STAFF REPORT 03-11-2020 REGULAR MEETING

**APPLICATION NUMBER: 20-6649**

ADDRESS: 31 ARDEN PARK BOULEVARD (HENRY STEINBRECHER HOUSE)

**SCOPE:** ERECTION OF FENCE (WORK COMPLETED IN VIOLATION)

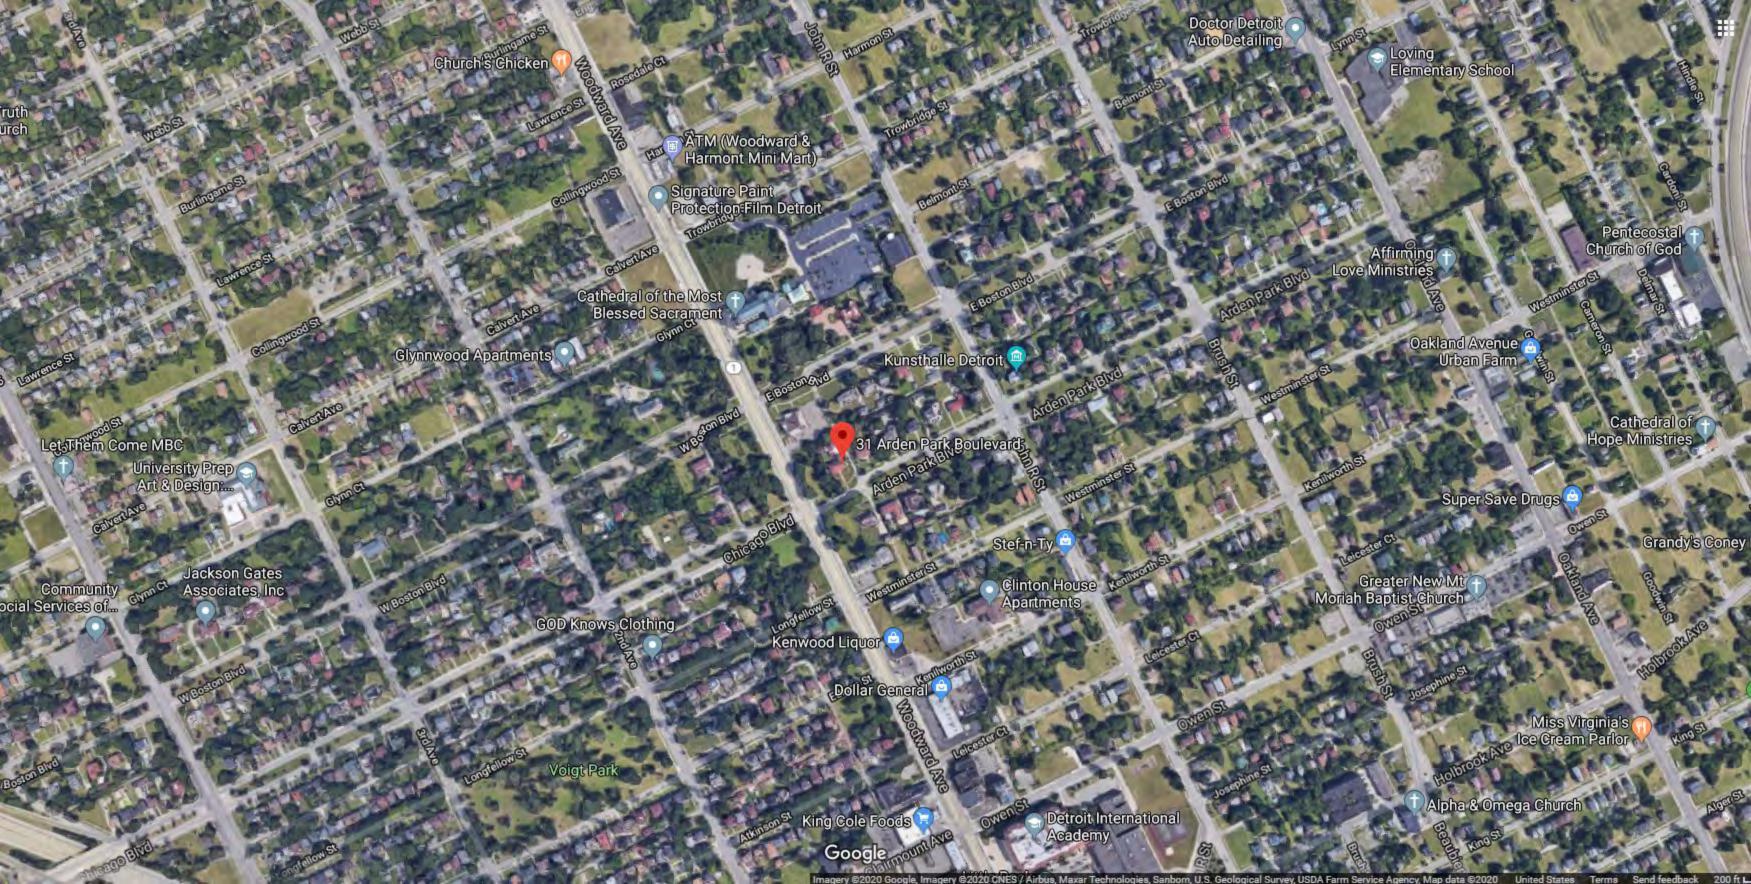
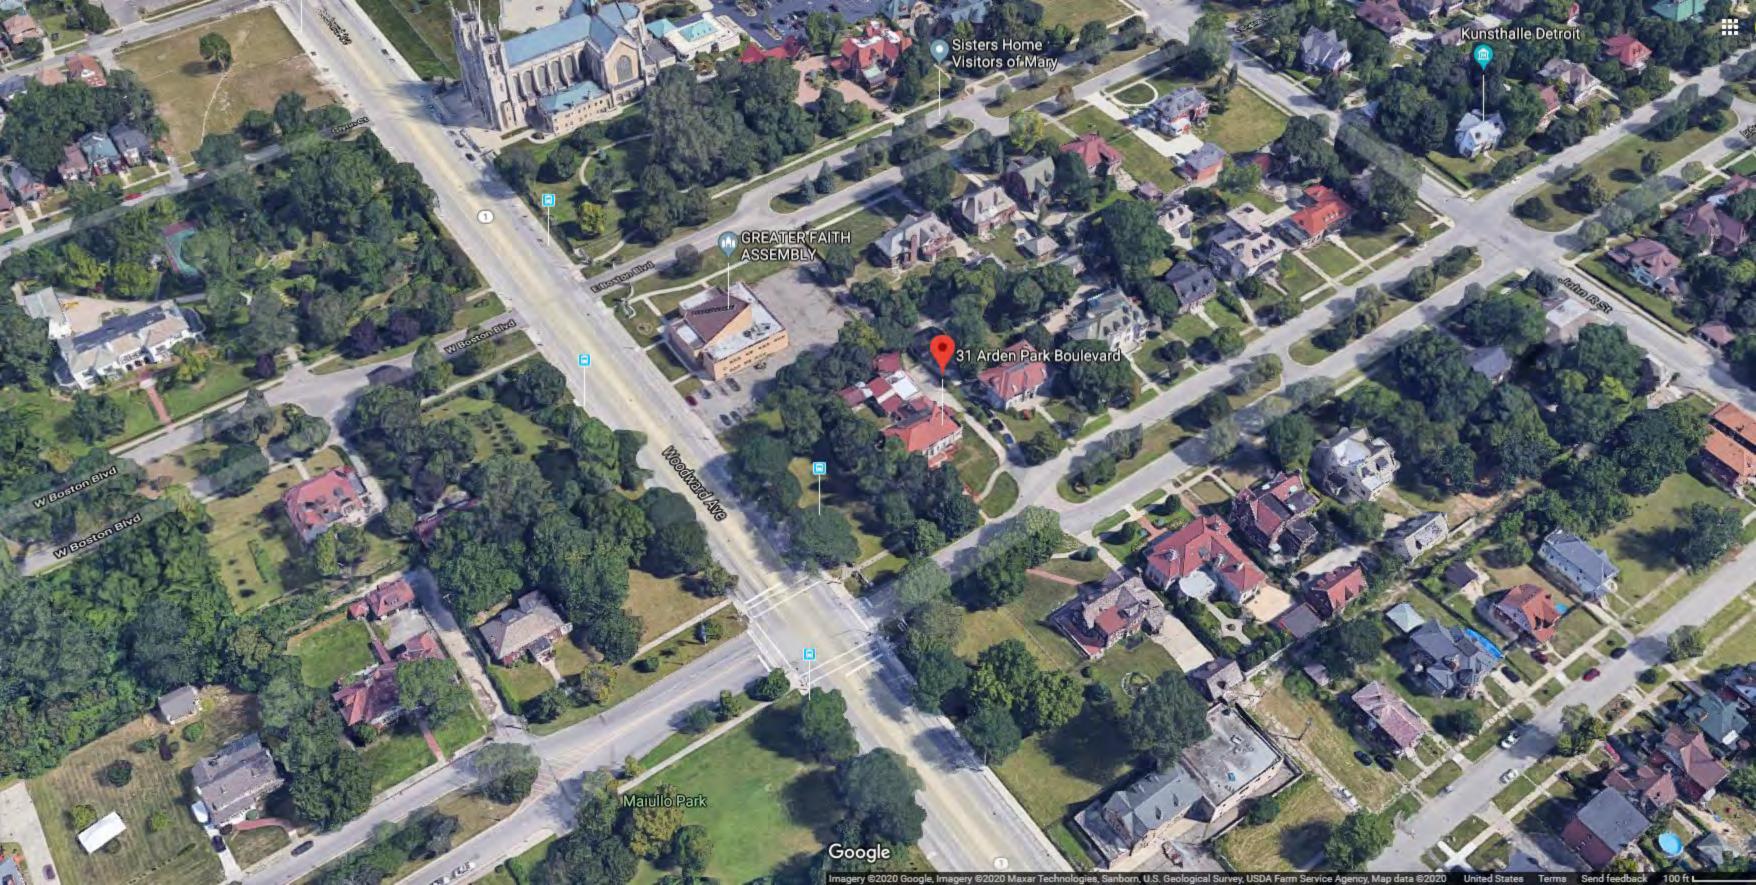
- The 8' height of the new fence does not meet the Commission's Fence & Hedge Guidelines as an allowable height at side lot lines. Additionally, not all of the fencing found on the property was replaced, only a portion of it. The remaining fence along the east lot line is black wrought iron, a short portion of chain link fence extends perpendicular to the new fence at the south elevation -- past the front face of the house, and a small section of 8' tall wood fence exists adjacent to the driveway west of the house. See submitted diagram for locations and fence types. Note that the portion of the chain link fence that exists perpendicular to the new wood fence at the front yard (past the front face of the house) is not represented in the diagram. There are currently 3 types of fencing material on the lot which does not meet the Commission's Fence & Hedge Guidelines which state, "A single lot shall contain no more than two types of fencing material."

- The fence is currently unpainted wood. While the application does not include any information regarding proposed finish for the fence, the applicant has indicated to staff their willingness to paint or stain the fence a color compatible with the house.

- It is staff's opinion that the lattice portion of the new fence detracts from the historic character of the property and is therefore not considered appropriate.

- The lattice portion located at the top of the fence be removed.
- The fence be stained or painted to complement the house.
